ADDENDUM

Reference: Navajo Trusts Facility Parking Lot Reconstruction Phase I
Blanding, Utah
DFCM Work Order #10483541

Subject: **Addendum No. 1**

ADDENDUM NO. 1

WORK ORDER NO.
 10483541
 SHEET NO.
 5

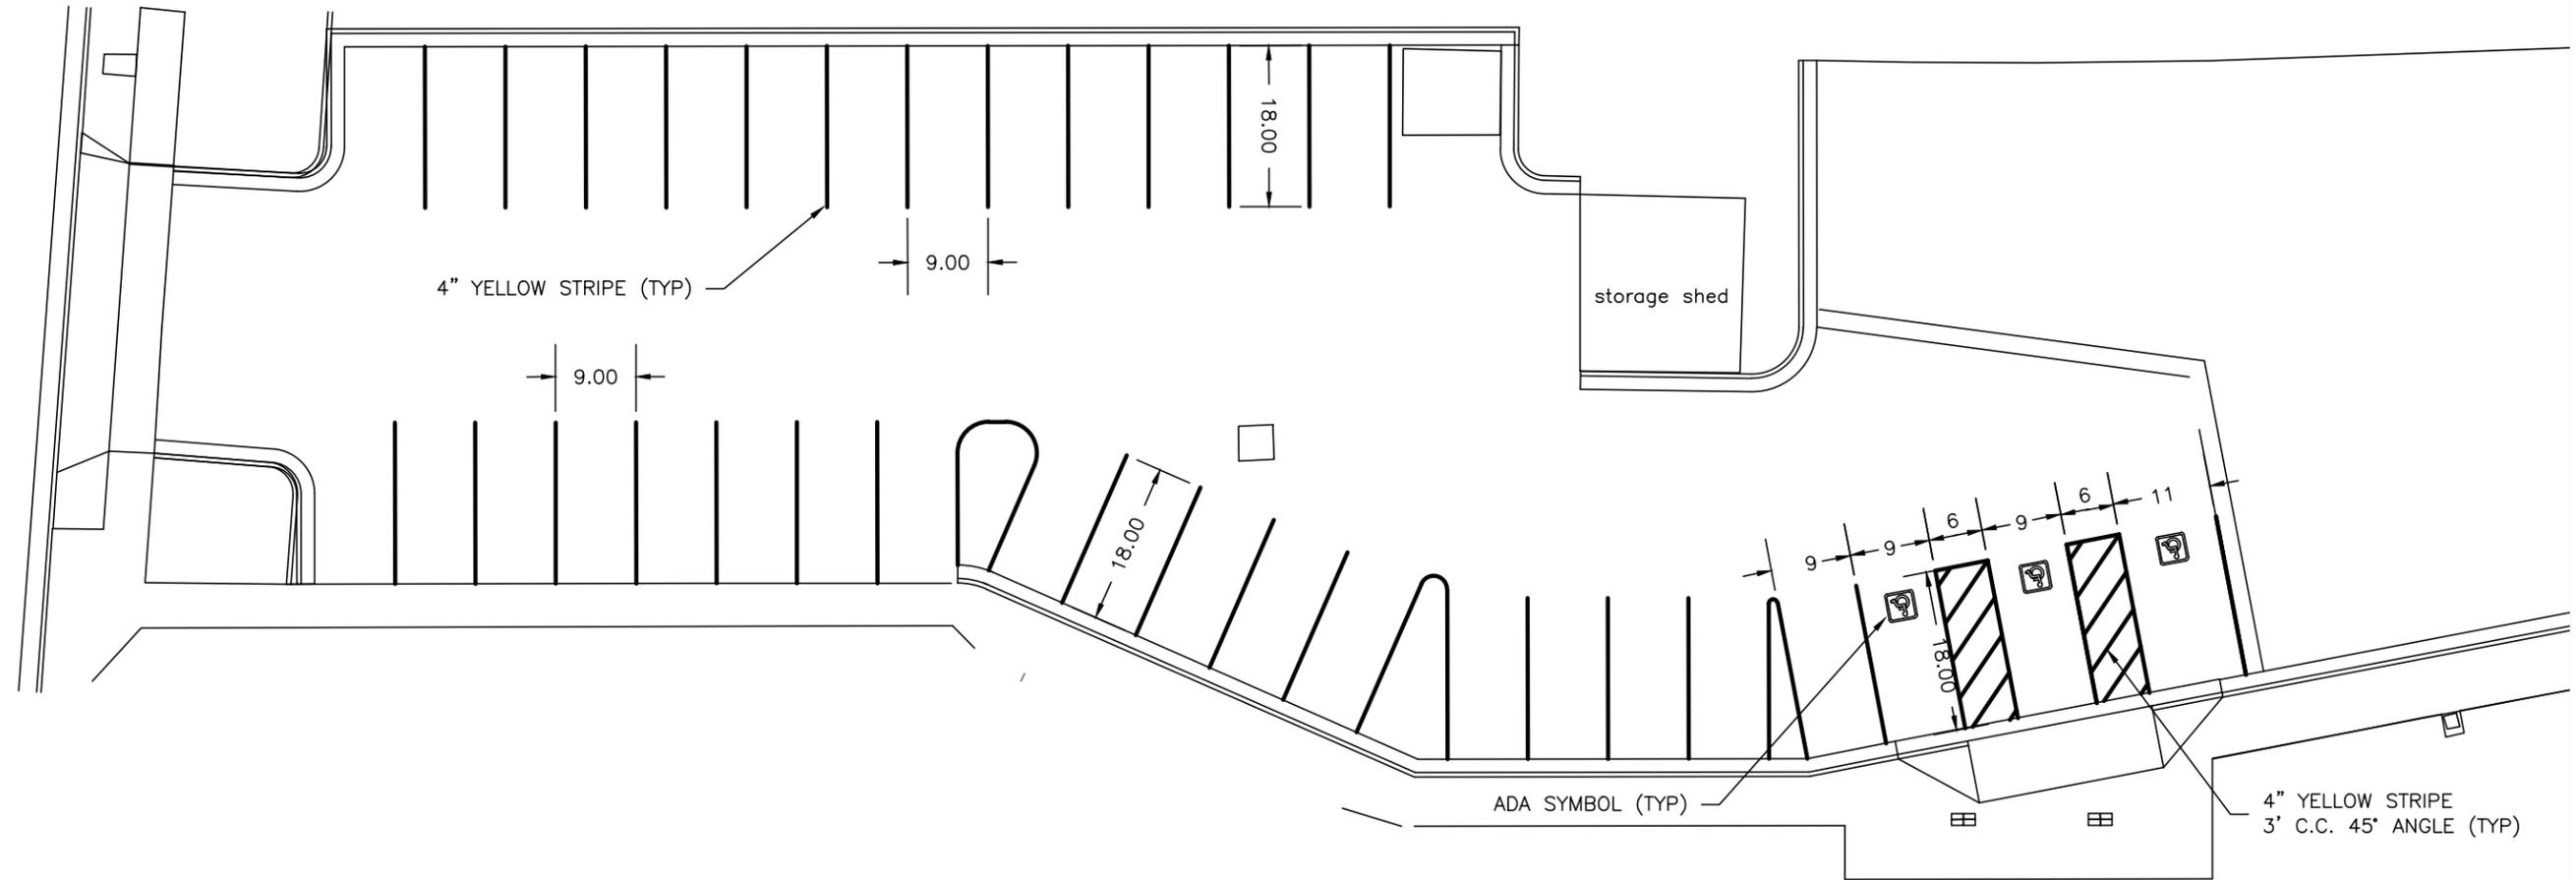
36" X 48" SIGN REQ'D.
 1/2" CDX PLYWOOD OR EQUAL
 BLACK LETTERS ON WHITE BACKGROUND

TEMPORARY ACCESS REQ'D.
 TIGHT BLADE AND PLACE
 3" UNTREATED BASE COURSE

FILL GUTTER WITH UTBC
 FOR TEMPORARY RAMP

ALTERNATIVE ADDITIVE
 ACCESSIBLE RAMP REQ'D.
 REMOVE SIDEWALK, CURB AND GUTTER
 AT NEAREST APPROPRIATE SEAM, OR SAW CUT
